**RE: RESPONSES TO REQUEST FOR ADDITIONAL INFORMATION ON
CRYSTAL RIVER PLANT UNITS 4 AND 5
FGD BLOWDOWN PONDS
SITE CERTIFICATION MODIFICATION N**

Golder Associates Inc. (Golder), with input from Progress Energy Florida (PEF) has prepared the following responses to the request for additional information (RAI) from the Florida Department of Environmental Protection (FDEP) dated July 24, 2009. The numbering of the responses corresponds to the numbers in the RAI:

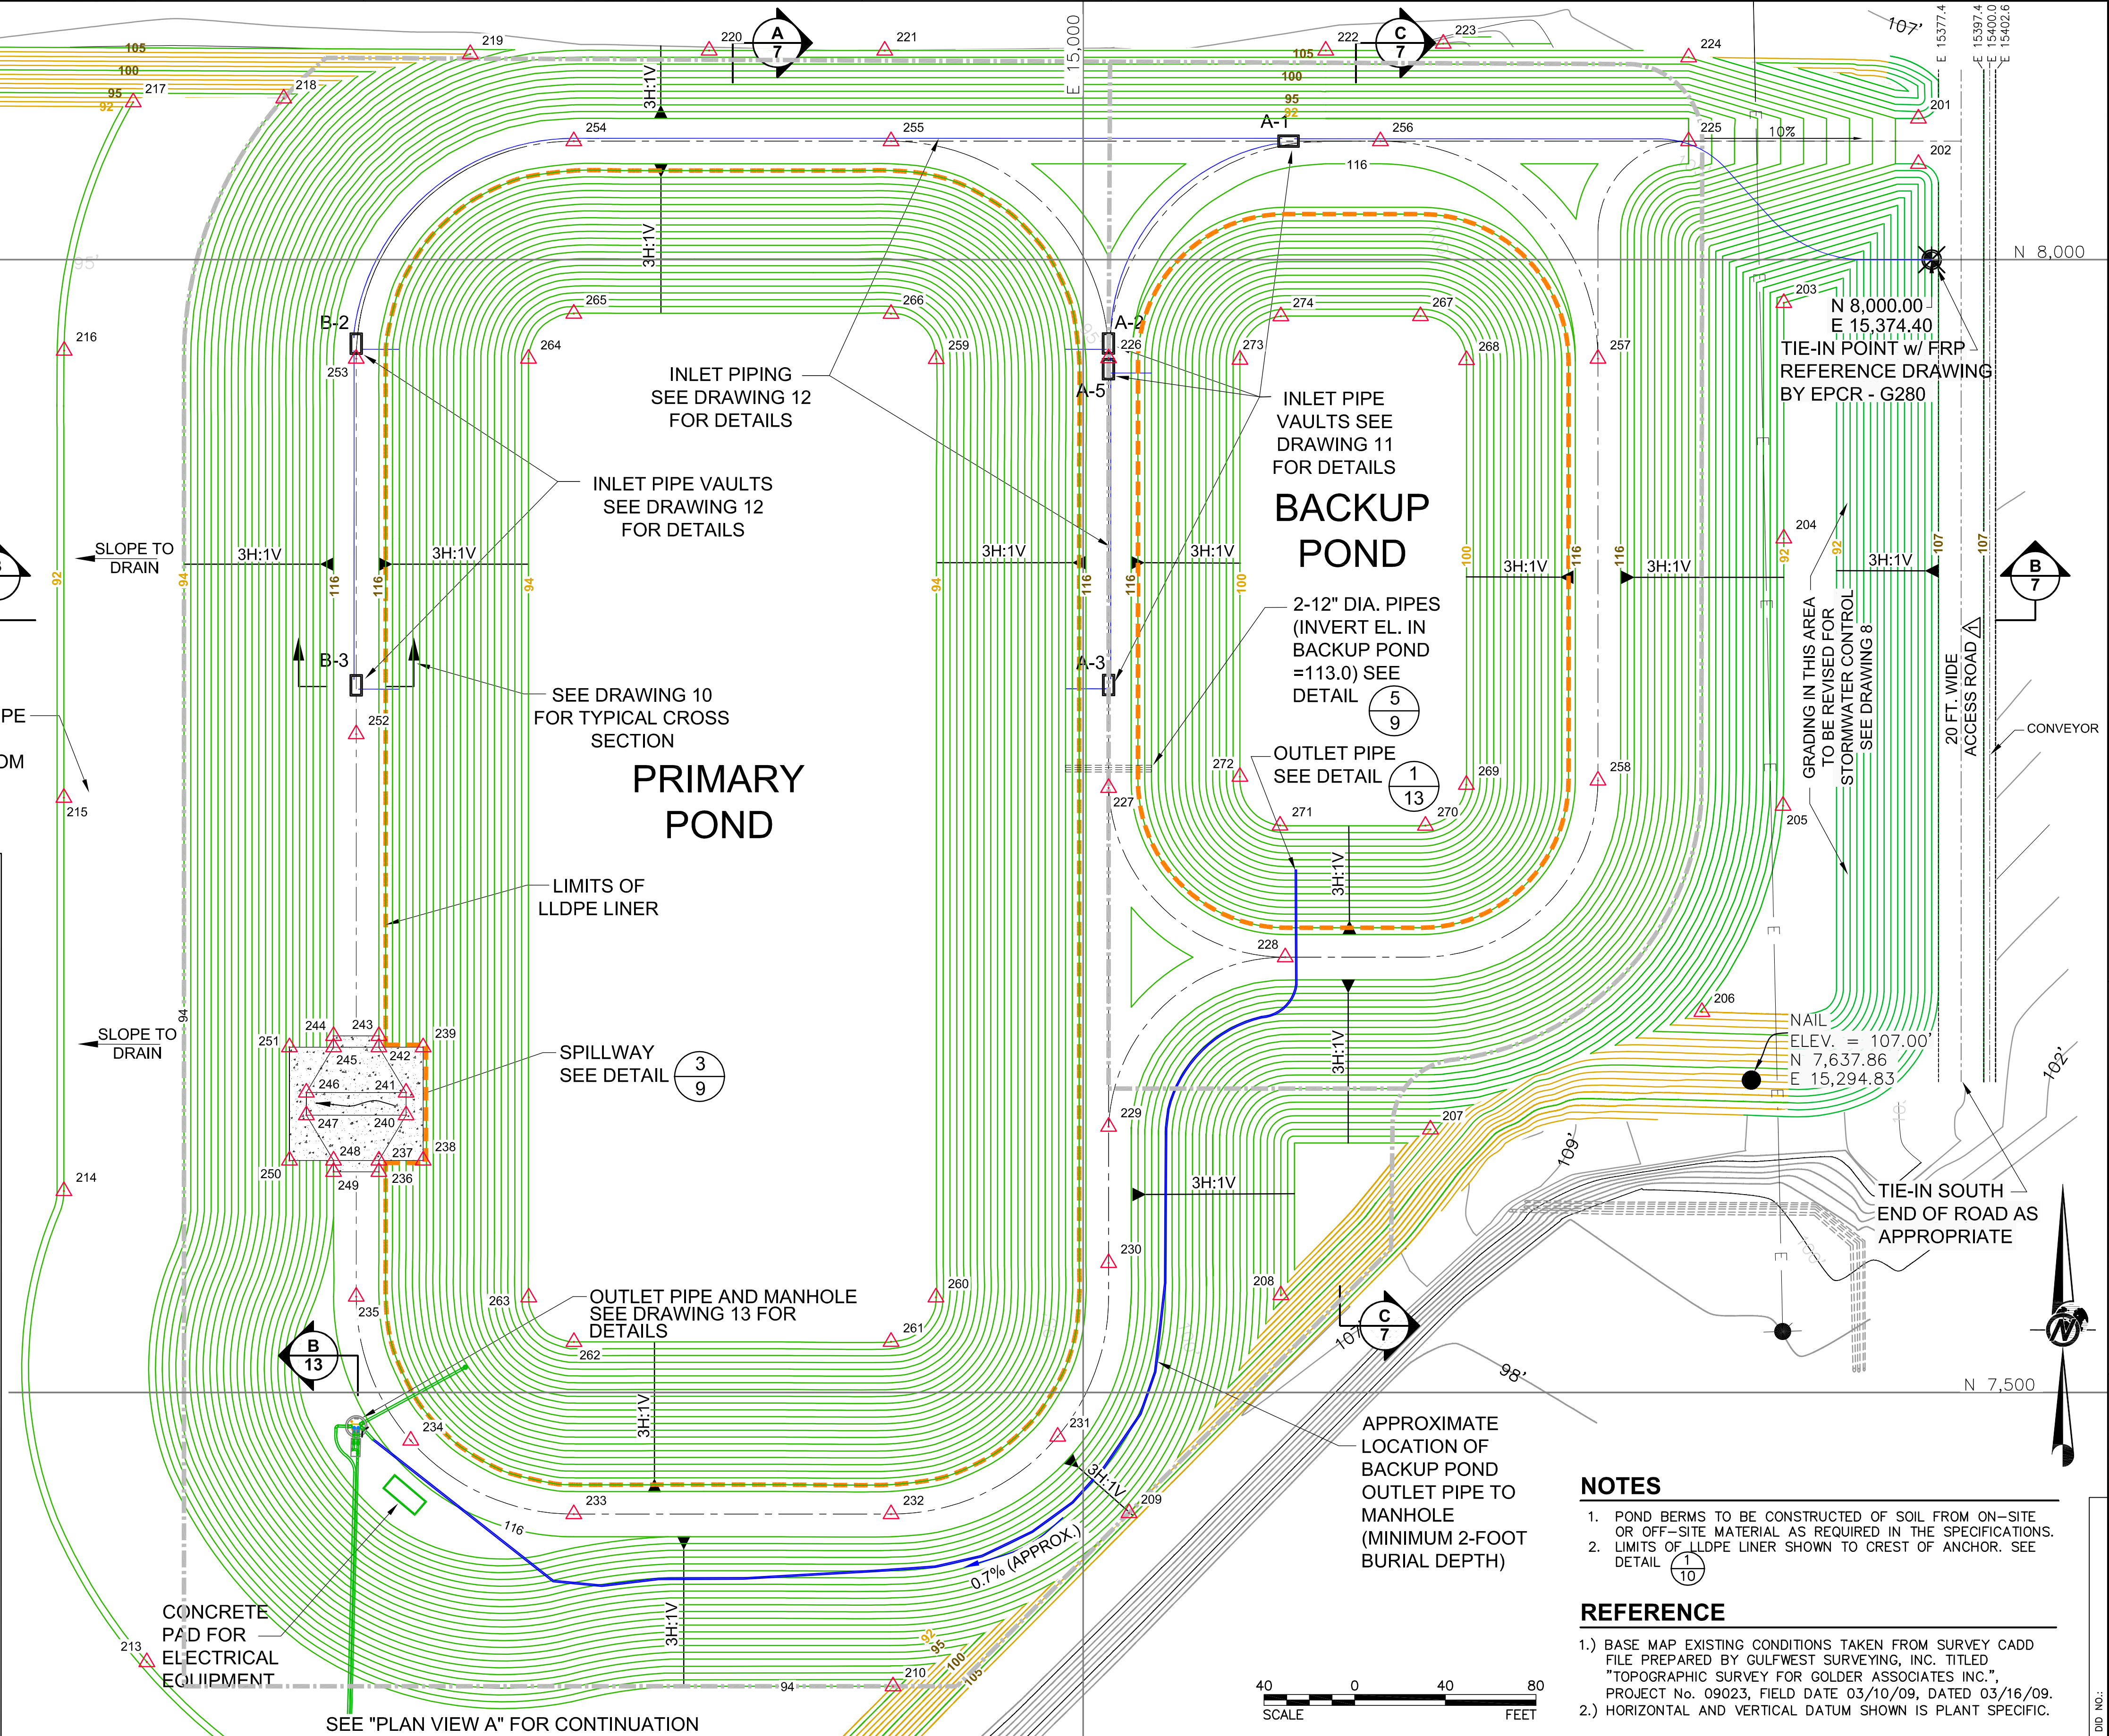
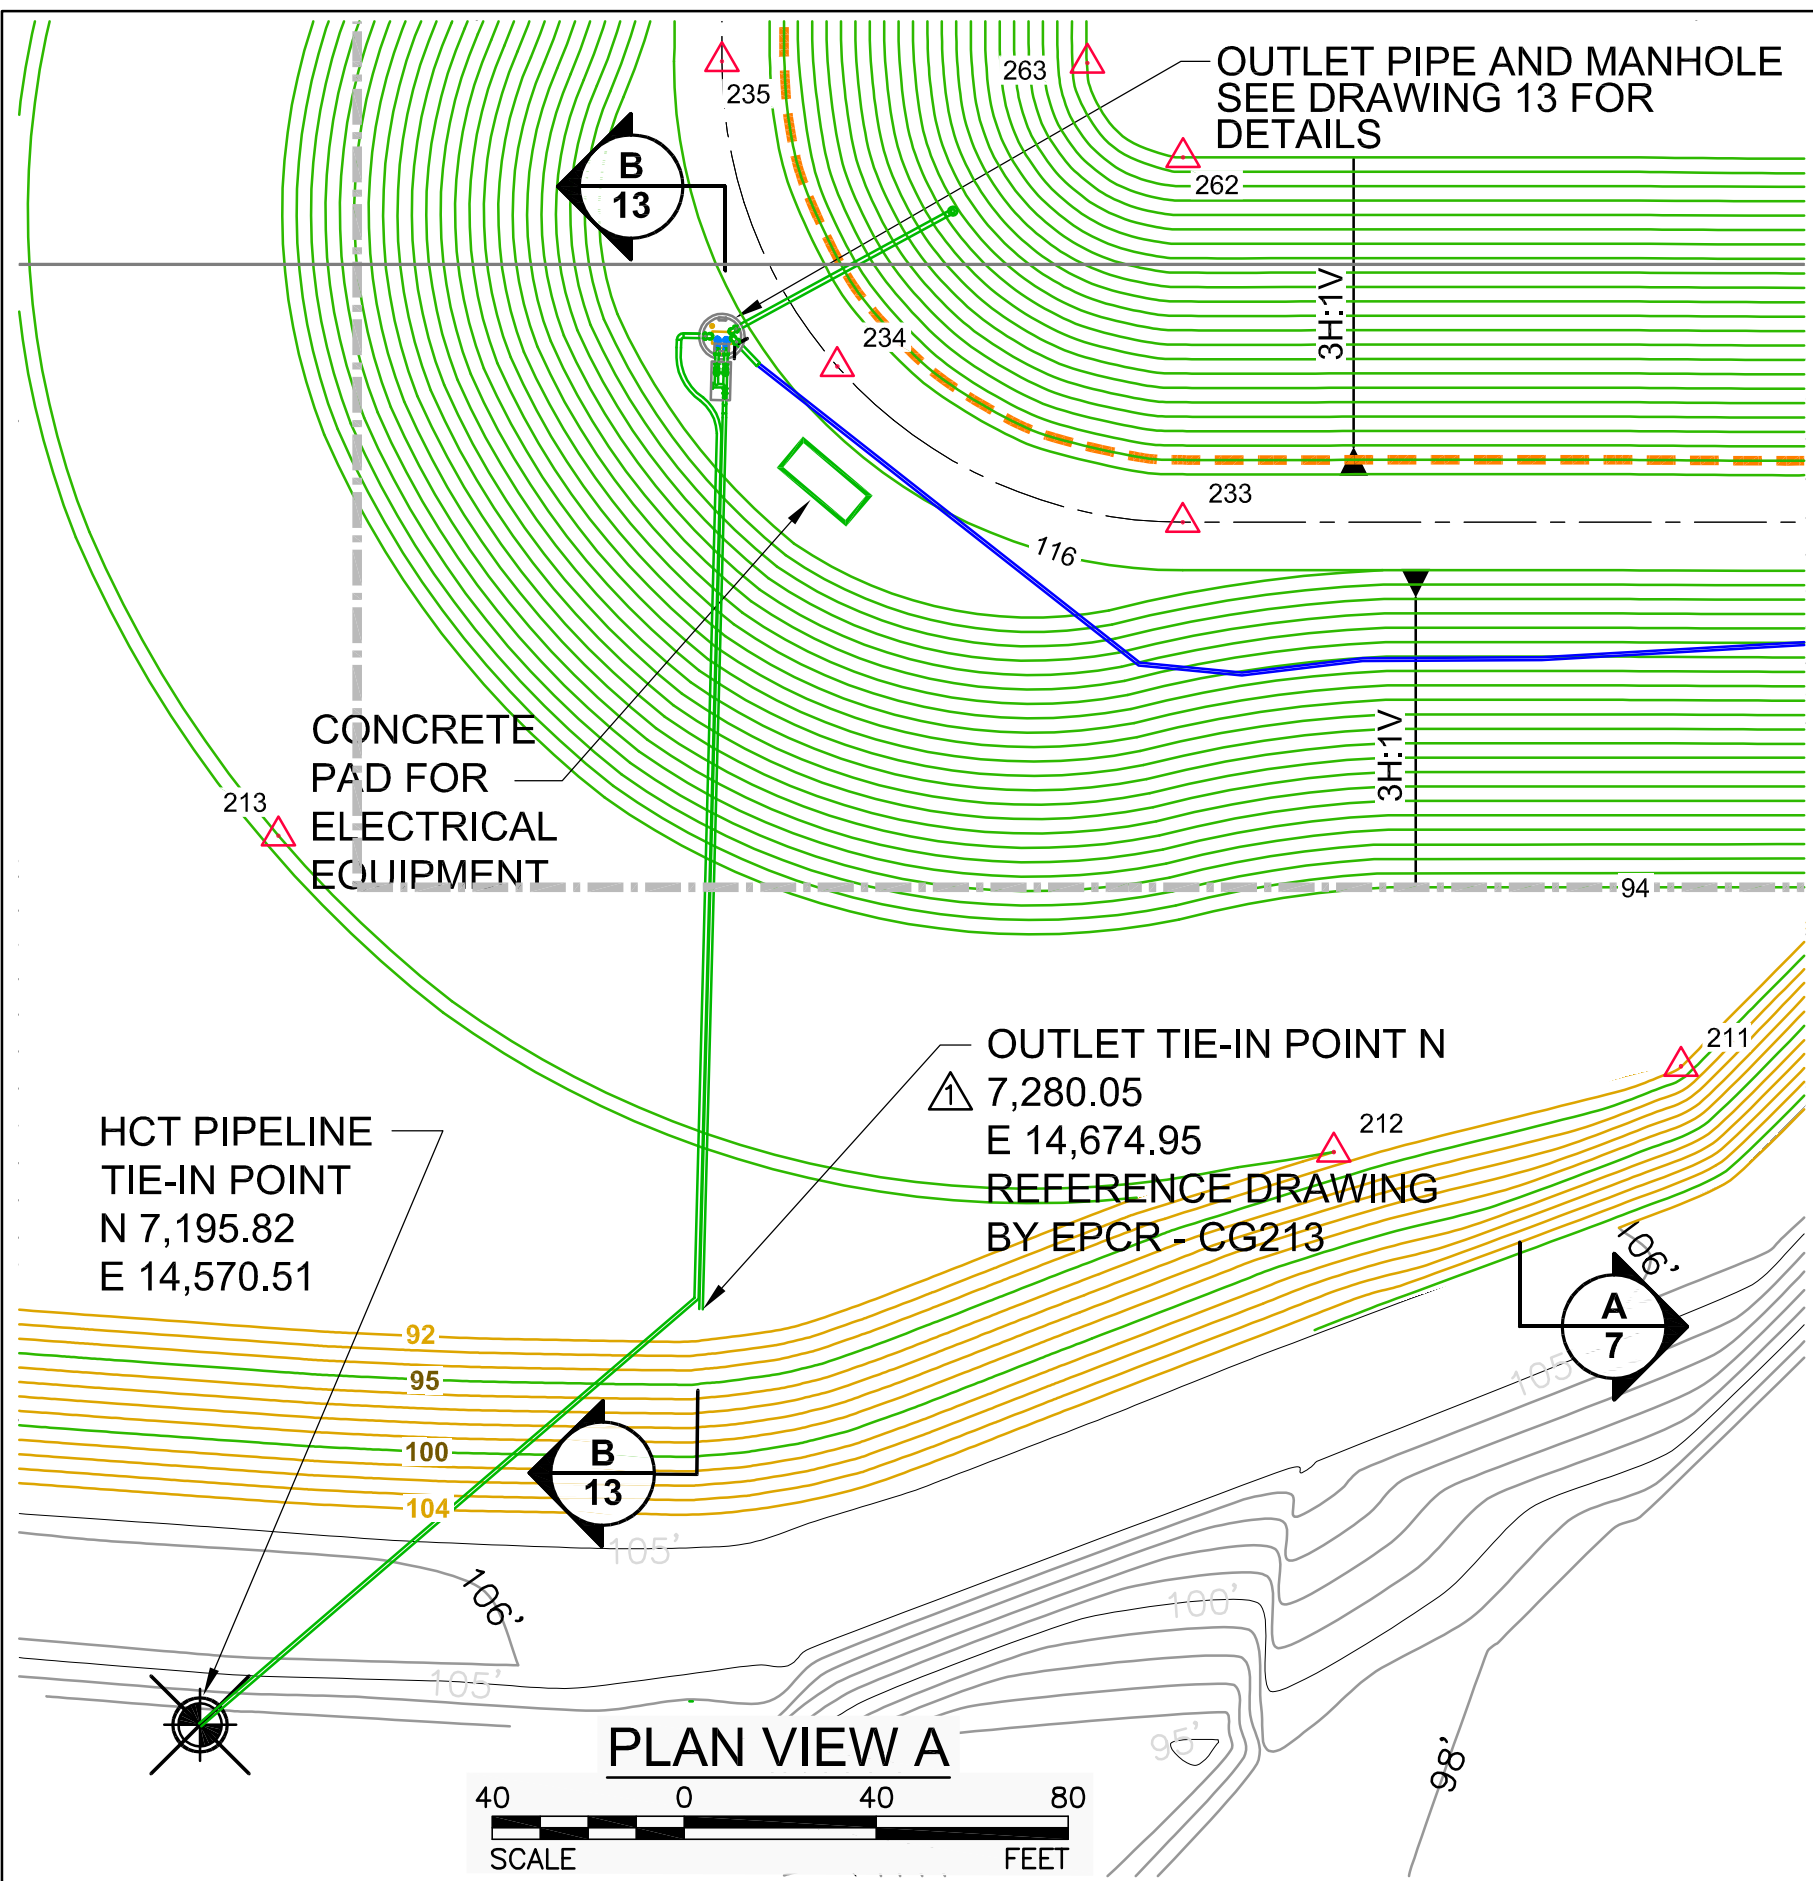
13. Drawing 6 has been revised to remove the "vault by others" as a vault will not be required at this location. The coordinates for the tie-in location are correct and the two pipes will be joined at this location. This drawing is included in Attachment C to these responses².

² It is noted that revisions in addition to the removal of the vault have been included on Drawing 6. The other revision comprises including the existing conveyor on the east side of the FGD Ponds as well as a limerock road adjacent to the conveyor to be constructed by the Contractor. Drawing 8 also includes these revisions and has been included in Attachment C as it is utilized for revised calculations (see responses #1 and #3 under Environmental Resource Permitting).

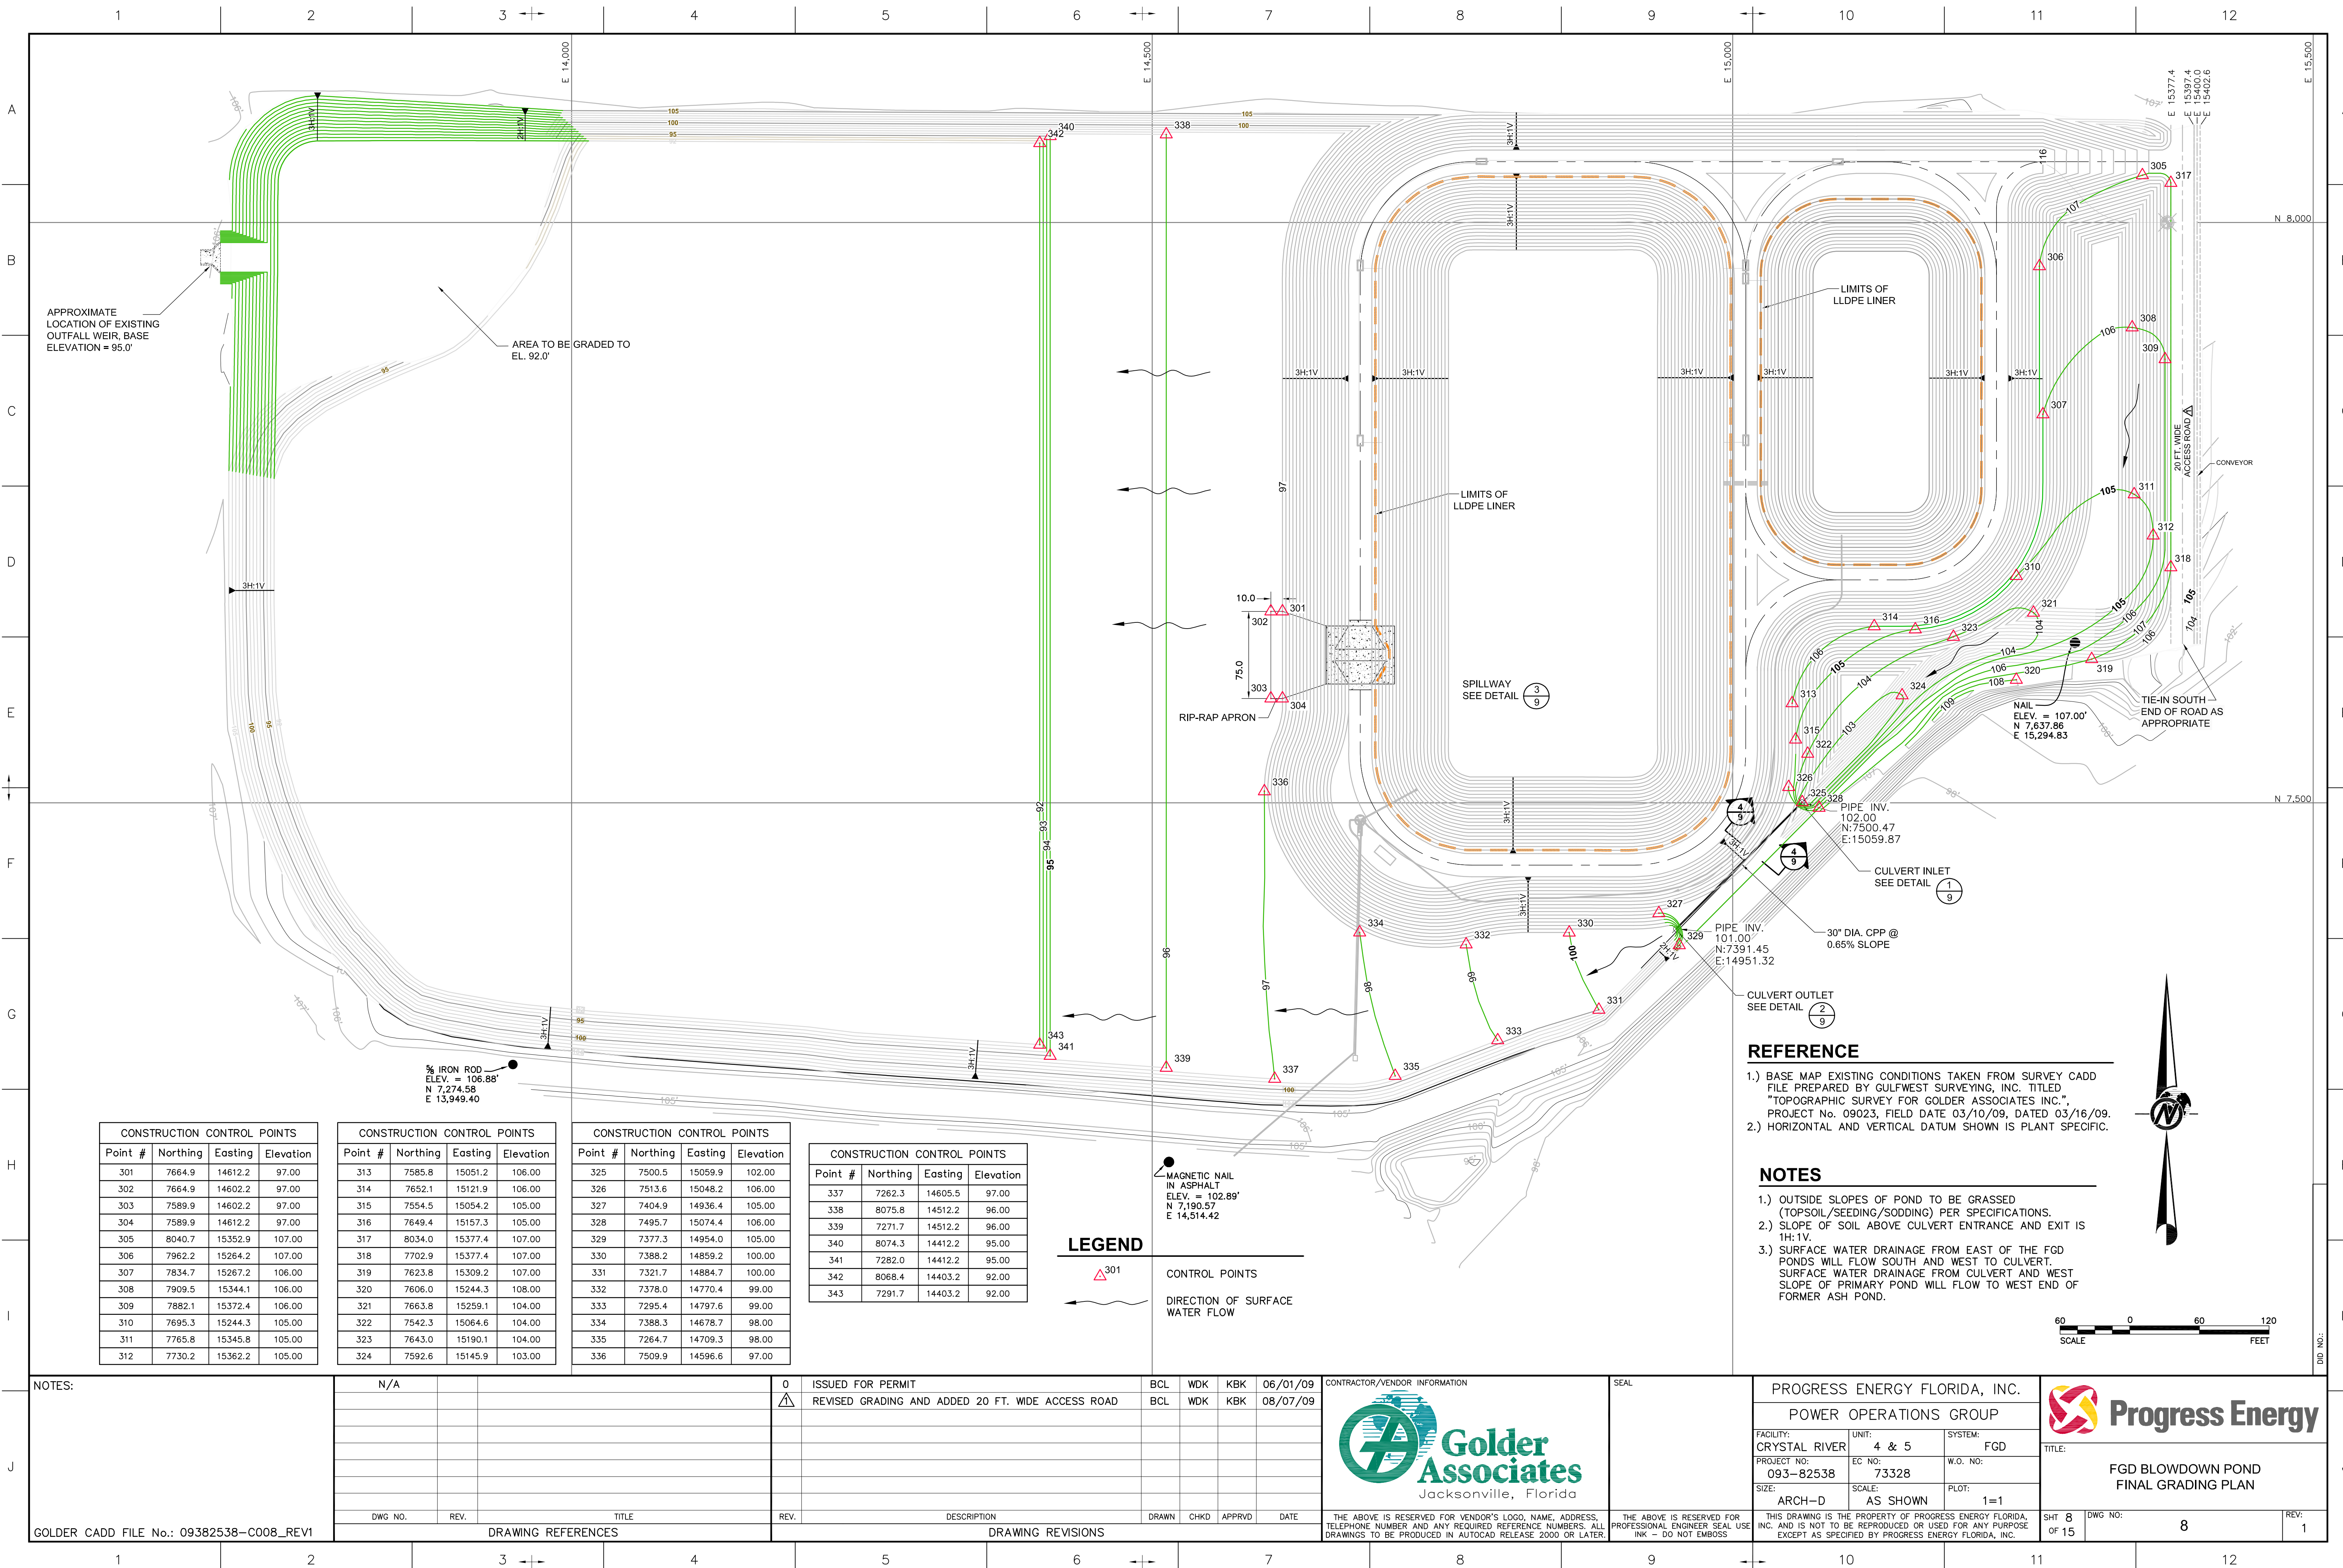
14. Drawing 7 has been revised to show the appropriate anchor trench references for each end of each cross section. This drawing is included in Attachment C to these responses³.

³ See footnote 2 – Drawings 7 and 8 are revised accordingly.
